**SUBJECT:** NuScale Power, LLC Response to NRC Request for Additional Information No. 236 (eRAI No. 9103) on the NuScale Design Certification Application

**REFERENCE:** U.S. Nuclear Regulatory Commission, "Request for Additional Information No. 236 (eRAI No. 9103)," dated September 25, 2017

NuScale Response to NRC Request for Additional Information eRAI No. 9103

**INTEGRAL STEAM PLENUM**  
(SIDE VIEW - CUTAWAY)

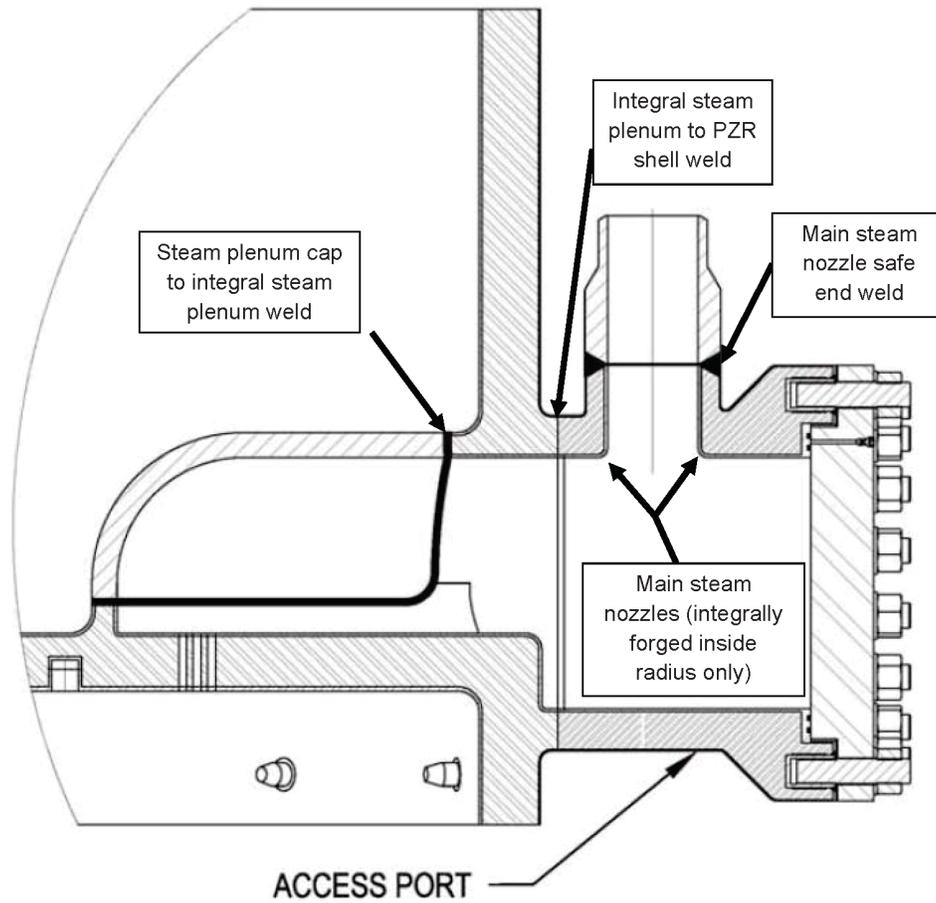
In the DCD, the drawings showing the penetrations through the reactor pressure vessel shell and head appear to show that the nozzles are integral to the shell and head materials (e.g., Figure 5.4-4) and no nozzle-to-shell or nozzle-to-head welds are shown in these figures. Table 5.2-6 describes the nozzle-to-vessel and nozzle-to-head welds as Examination Category B-D, “Full Penetration Welded Nozzles in Vessels.” This is an inconsistency in the two sections of the DCD.

Revise the DCD to resolve this inconsistency, describe how the nozzles are attached to the vessel and head, and provide the proposed ISI requirements for the nozzles so that the staff can confirm that the locations will meet the accessibility for inspection requirements of 10 CFR 50.55a (3)(i).

Reactor pressure vessel head nozzles are integrally forged into the head material. There are no welded nozzles on the reactor vessel head. Examination Category B-D is specified to ensure the inside radii of the forged nozzles are examined as per Figure IWB-2500-7(d) in the ASME BPVC. Nozzles within the reactor vessel shell are welded.

Tier 2, FSAR Table 5.2-6 has been revised (See response to eRAI 9109, RAI 06.06-3) to add the applicable ASME Boiler and Pressure Vessel Code (BPVC) examination requirements. Figure IWB-2500-7(a) through Figure IWB-2500-7(d) in the ASME BPVC identifies the applicable method of nozzle attachment for each nozzle. The appropriate IWB-2500-7(x) figure is added for each nozzle attachment weld in the tables so the appropriate in-service inspection requirements are applied.

For clarity FSAR Figure 5.4-4 has been reproduced below and enhanced to identify the welds by name. Each weld is included in Table 5.2-6 along with the required examination method.
